We have received the UMTRA Project Surveillance and Maintenance Plan (PSMP: UMTRA DOE/AL -350124) transmitted to us by your letter dated April 3, 1985 (received April 8, 1985). Based on our review, we have the following general comments on the PSMP:

Division of Waste Management Specific Comments on the PSMP

DWM SPECIFIC COMMENTS ON THE
UMTRA PROJECT SURVEILLANCE AND MAINTENANCE PLAN

ATTACHMENT
EXAMPLE BOREHOLE LOGS
(from DOE/EIS-0099-D)

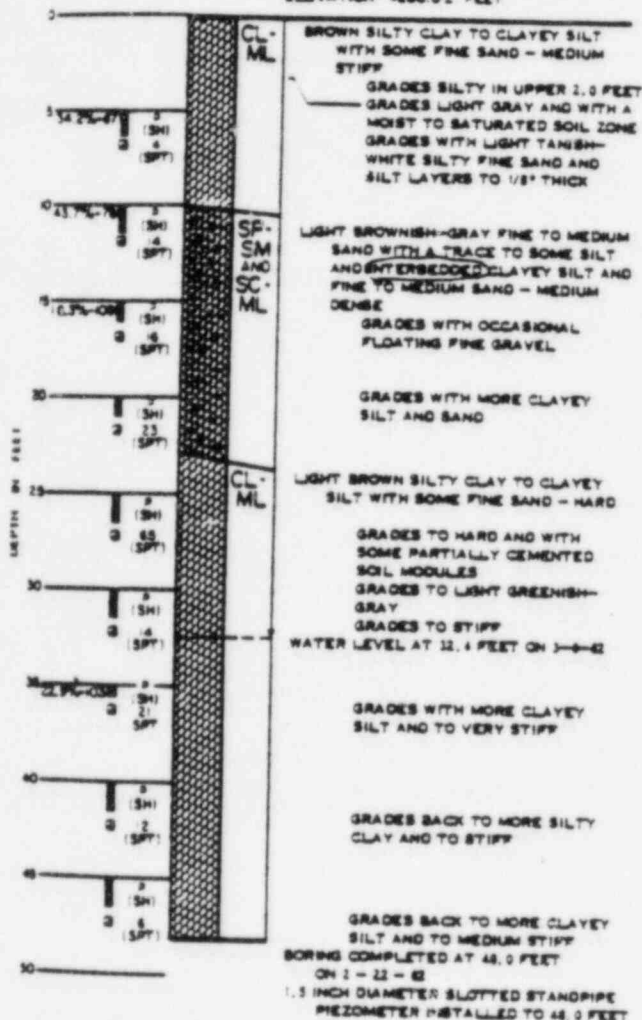
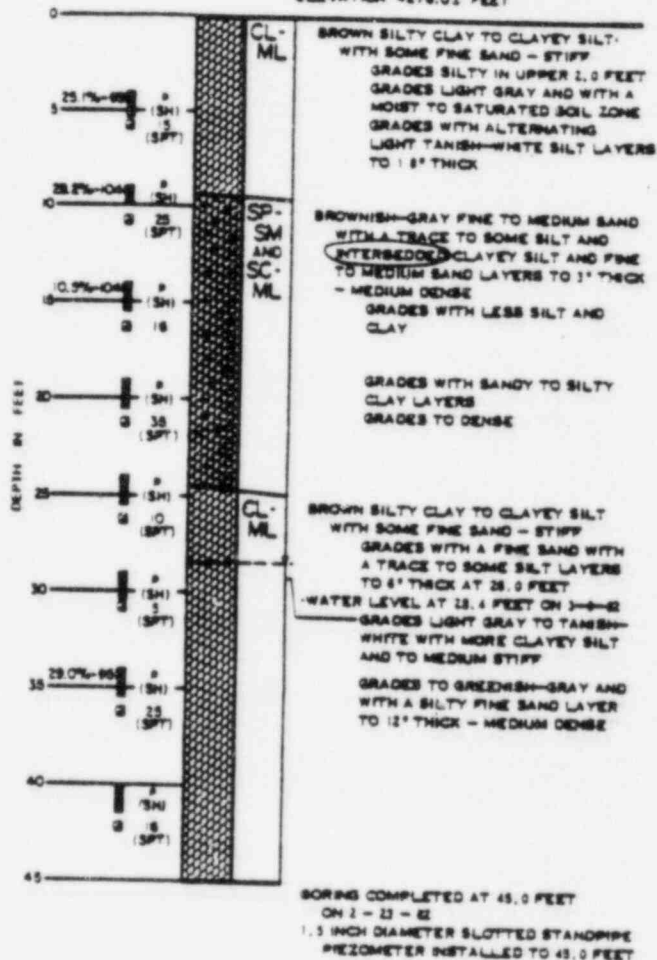
The borehole log form (Figure 2.8) appears to be an inefficient form for communicating and recording borehole logs. Standard borehole logs that provide a graphical representation of the units penetrated by boreholes are easier to read and in a glance can provide a rapid summary of the lithologies or sediment types encountered in borehole. Examples of such logs have been prepared at several UMTRAP sites, including the logs prepared by Dames and Moore at the South Salt Lake UMTRAP site or the logs by Bendix at the Durango UMTRAP site. If DOE decides to include examples of borehole log forms in the PSMP, the NRC staff recommends that Figure 2.8 be revised to increase the form's efficiency in recording and communicating information (see examples attached).
